**DEVELOPMENT AGREEMENT (REF: HRM CASE #21099)  
APPLICATION FOR A SUBSTANTIVE AMENDMENT  
MULTI-UNIT RESIDENTIAL BUILDING, FOURTH STREET, BEDFORD**

December 13, 2019

**Re: Bedford Highway & Fourth Traffic Impact Statement Addendum**

**Exhibit 1 – Bedford Highway and Fourth Street Site Plan**

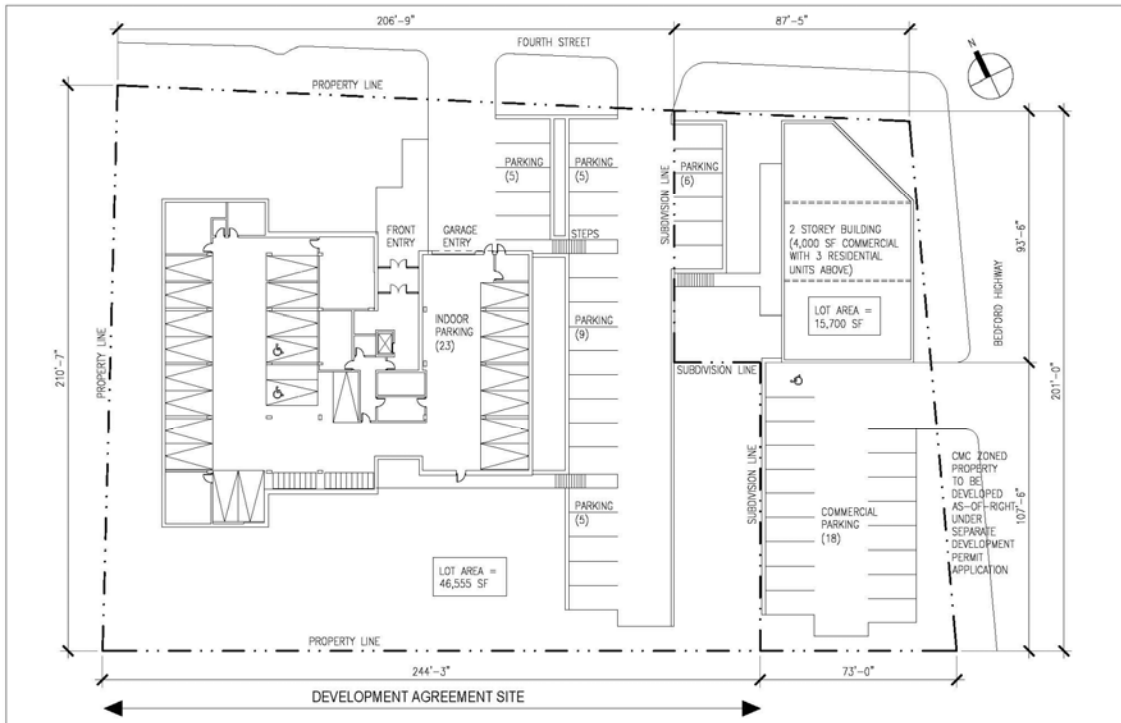
The developer has revised their plans for the site and Phase 1 will now have 4,000 sqft of Commercial/Retail space on the Ground Level accessed from Bedford Highway with 3 apartments behind that will be accessed from Phase 2 once that is completed. Phase 2 will have 27 residential apartments and no townhouses. Refer to Exhibit 1.

The proposed changes will result in less traffic than the original plans as the Commercial/Retail space has been reduced, there are no townhouses and the total apartment count has been reduced by one unit.

SCHEDULE C:  
 LANDSCAPE PLAN

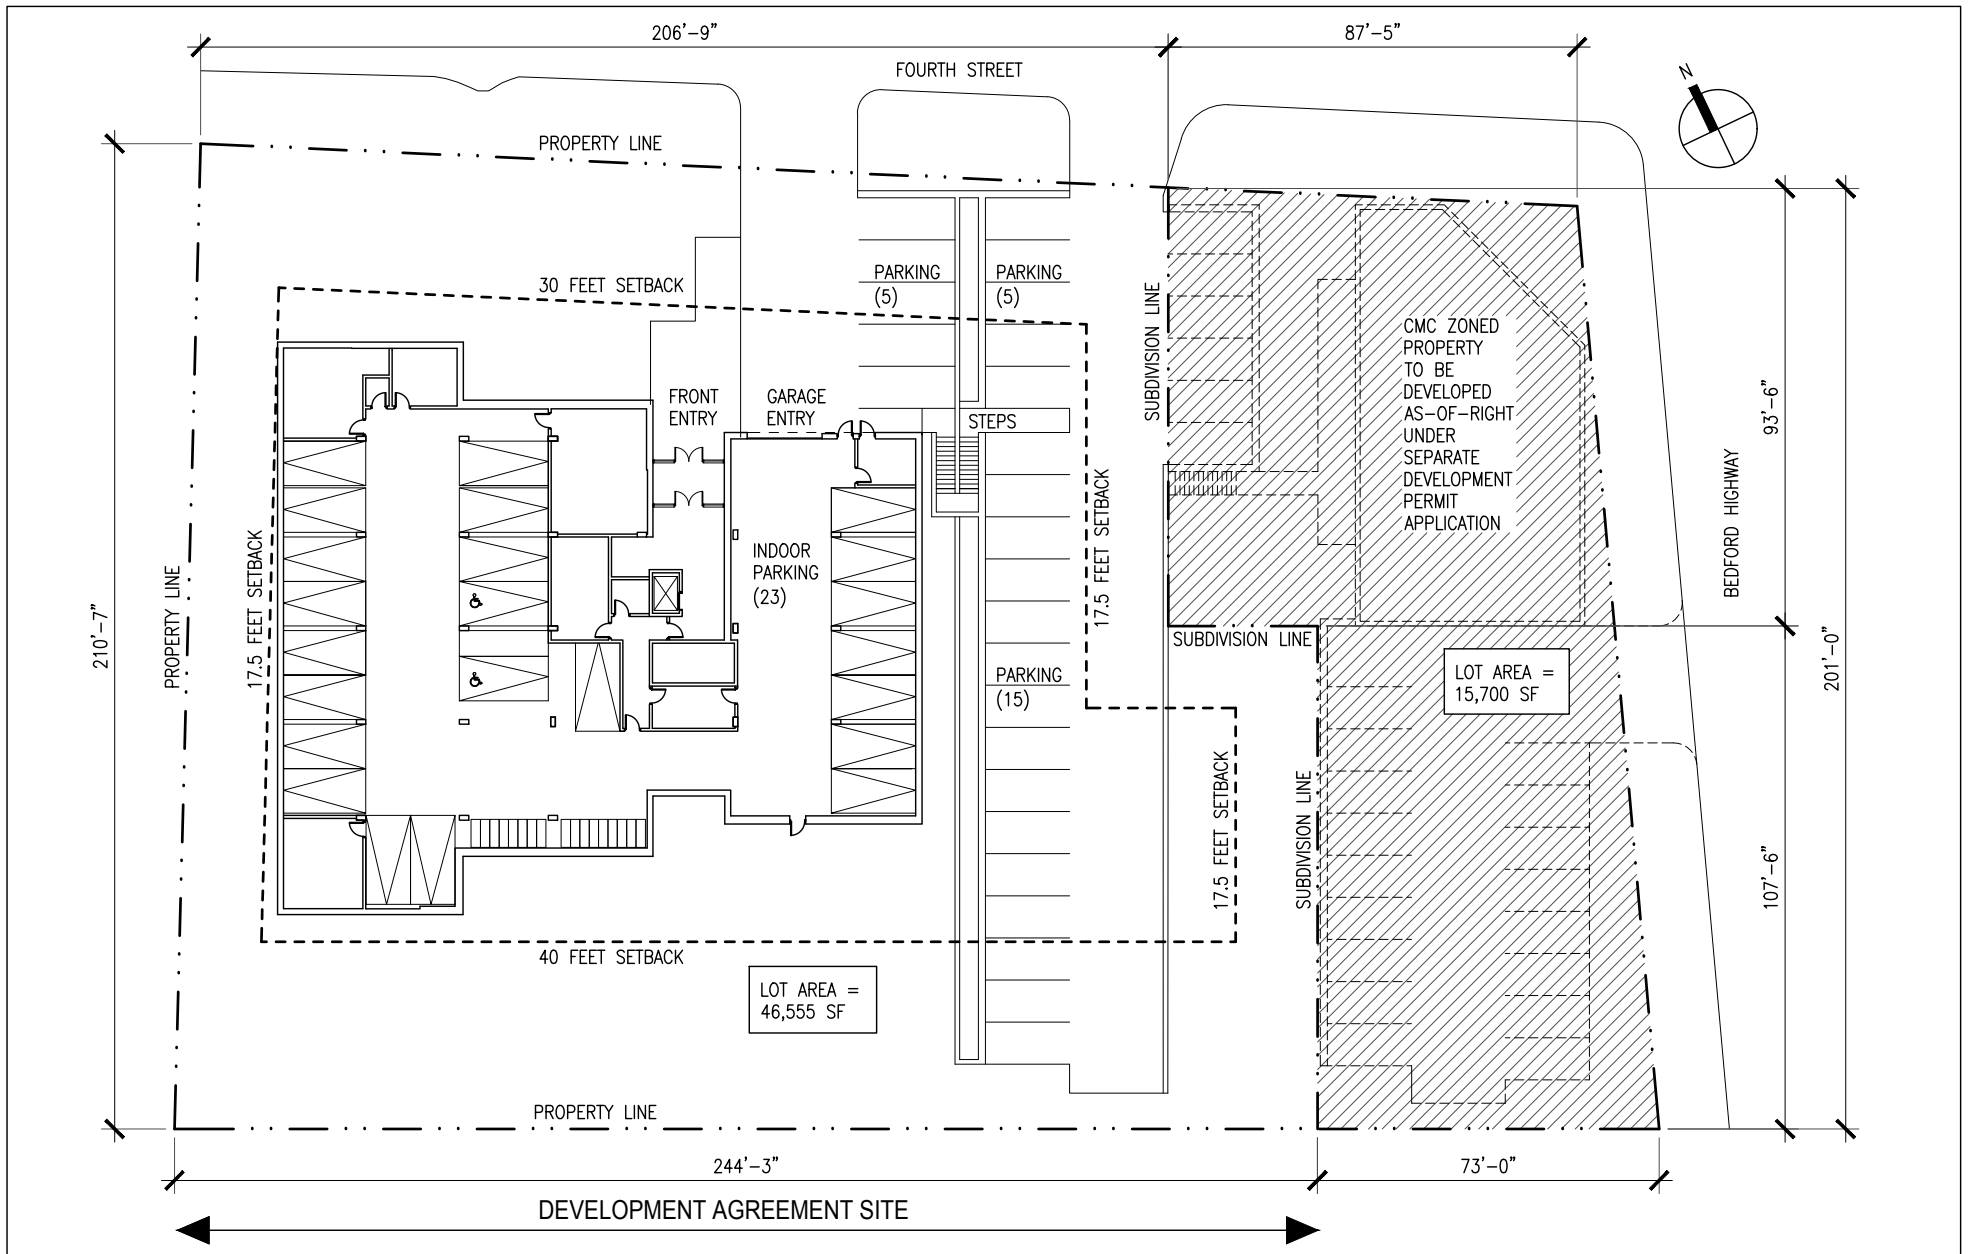
Reference: Schedule C: Landscape Plan  
Proposed Amendment: An amended Schedule C is enclosed.  
Description/Rationale: The Landscape Plan is amended similarly to Schedule B including associated amendments to grading, retaining walls and planting.  
In addition, the Landscape Plan illustrates conformance with Recreation Space

Schedule C indicates a total Recreational Space of 10,350 square feet, which meets the minimum requirement.

DRAWING TITLE:  
 SCHEDULE B:  
 SITE PLAN

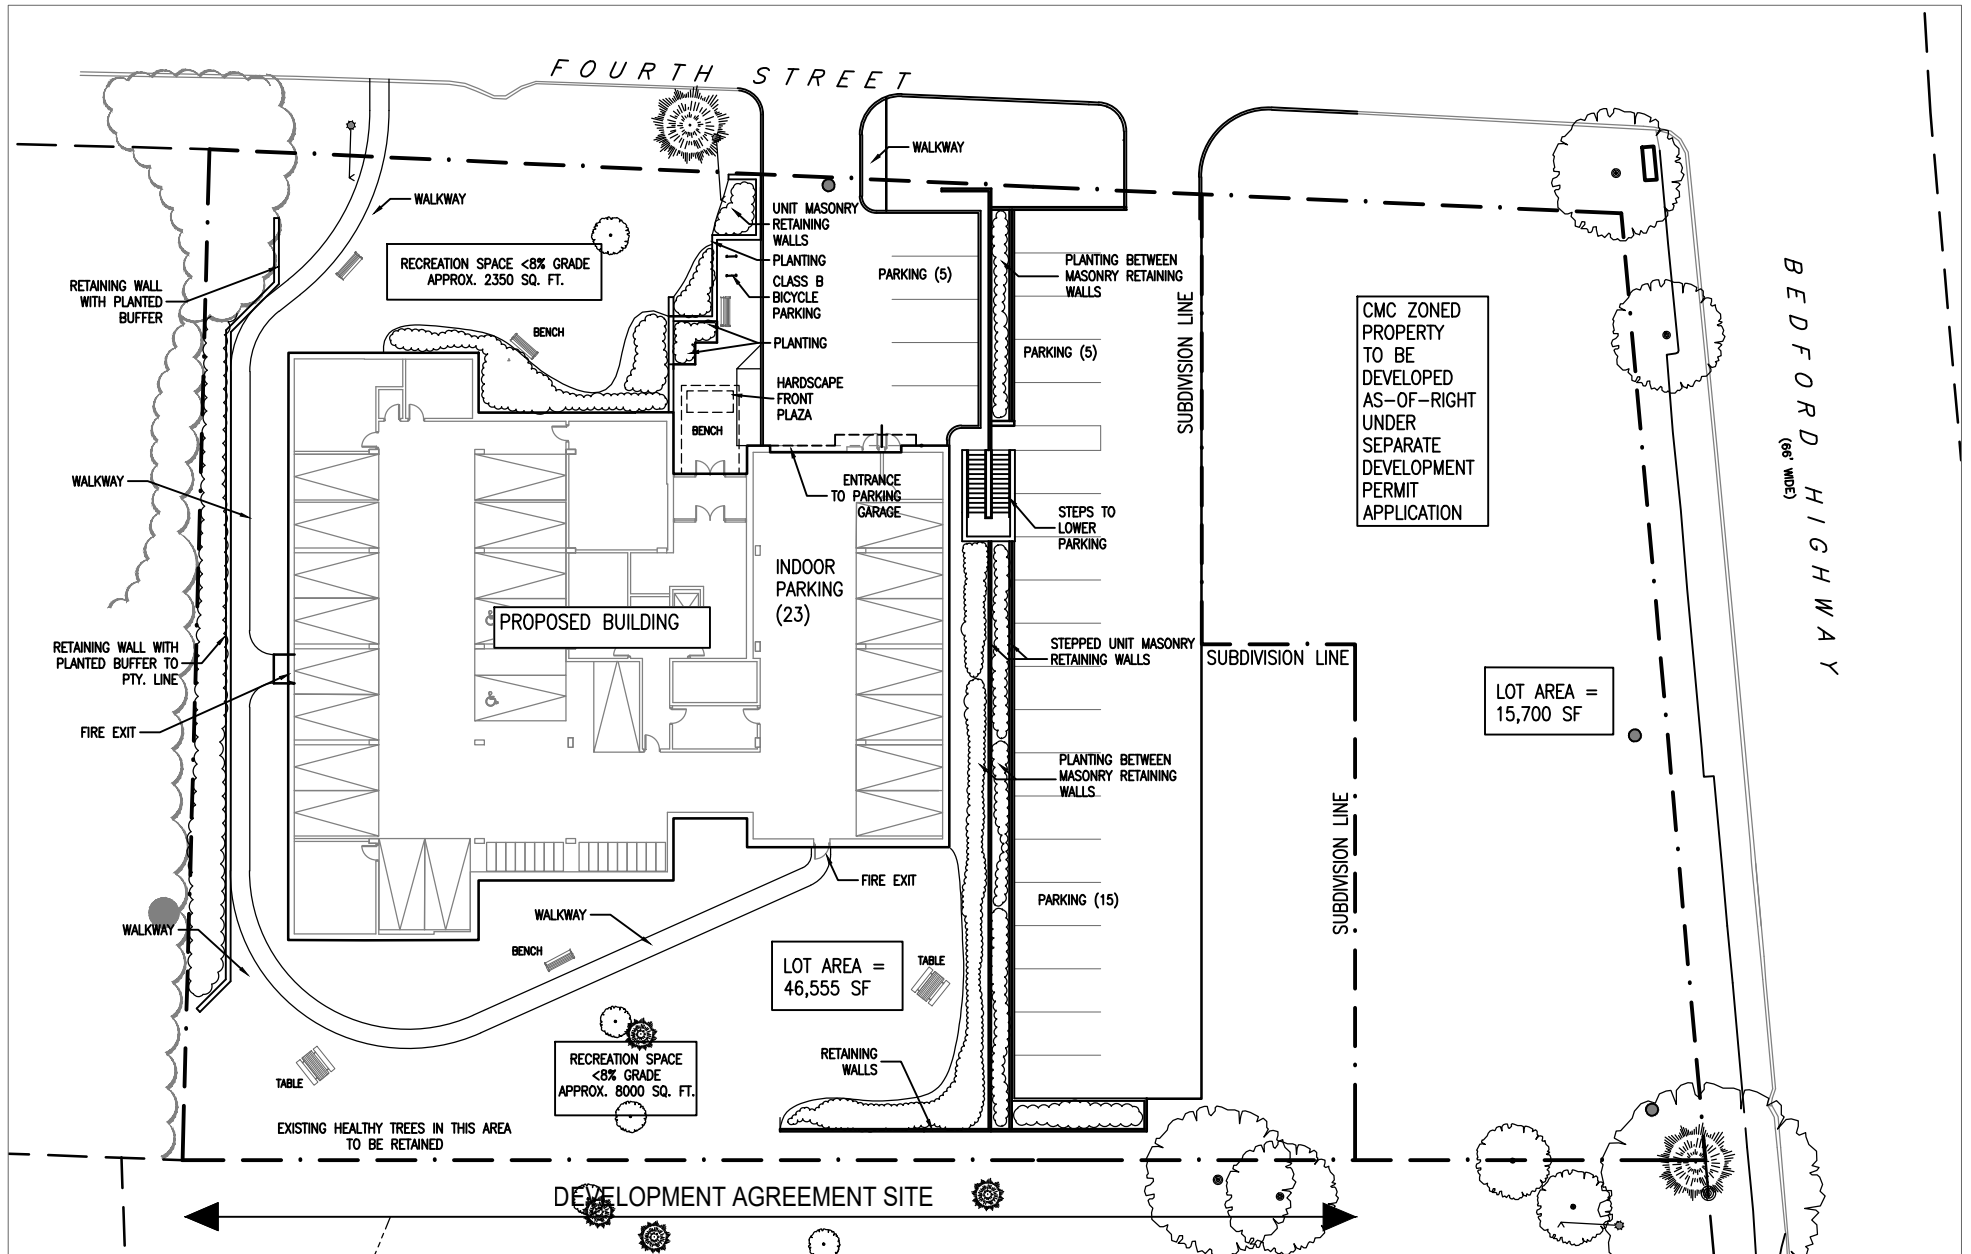
Reference: Schedule B: Site Plan  
Proposed Amendment: An amended Schedule B is enclosed. For information only, a suggested outline is provided for the adjacent CMC zoned lot, which will be subject to a separate Development Permit application.  
Description/Rationale: The site plan is amended to accommodate an increase in dwelling units from 18 to 27. This requires an increase in outdoor parking as well as an increase to the lot area.  
The building size, shape, layout and location remain unchanged. As well, the driveway to the parking garage entry and its associated 5 parking spaces and front entry area remain unchanged.  
For parking, an additional outdoor parking area is created along the eastern side of the lot between the building and line of subdivision. Due to the slope of the land, separate access is required to this parking area from Fourth Street. From this parking area, a set of steps are provided to allow access to the front entry.

As per above, a minimum lot area of 46,500 sq.ft. is required. Accordingly, the attached Schedule B: Site Plan illustrates an amendment to the line of subdivision in order to increase the lot area. As shown, the amended lot area is 46,555 sq.ft. This consequently reduced the area of the adjoining lot located along Bedford Highway, which is under the same ownership.

The proposed design, as illustrated on the attached Schedule B: Site Plan, provides an additional 20 outdoor parking spaces for a total of 25 outdoor spaces. In combination with the indoor parking garage, this provides a total of 48 spaces, which is 7 more than the minimum requirement.
